DEFECT REPORT

0 Nowhere St, Nowhere, NSW 0000

Issue Date: February 2019

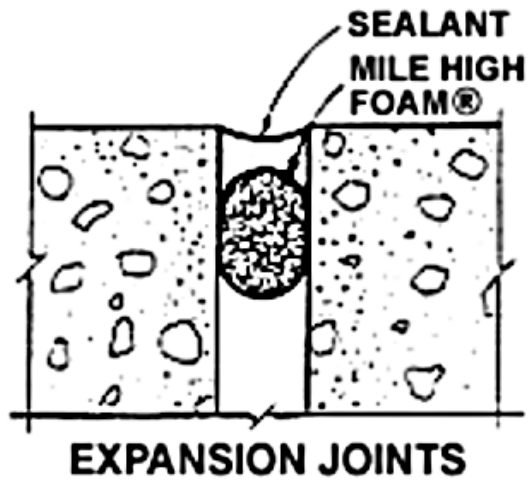
Item No.	Item Description & Cause	References (if applicable)	Brief Scope of Rectification Works	Photographic Record
<p>2.2</p>	<p>Carpark</p> <p>Trench drains behind car spaces: A605 A1104 B502 B503</p> <p>Trench drains are not connected to storm water catchment pit. Drain inlets are capped.</p> <p>Trench drains are poorly formed.</p>	<p>Australian Standard AS 3500.3 Plumbing Drainage and Stormwater Drainage. Section 6 Surface and Subsoil Drainage Systems.</p> <p>Home Building Act 1989 Section 18 - Warranty Breach, poor workmanship and unsightly.</p>	<p>Cut open line of trench drain and re-form with sufficient fall to drain inlet.</p> <p>*Preferably fit Ag pipe to discharge into drain inlet. Fill newly formed trench drain with blue metal.</p>
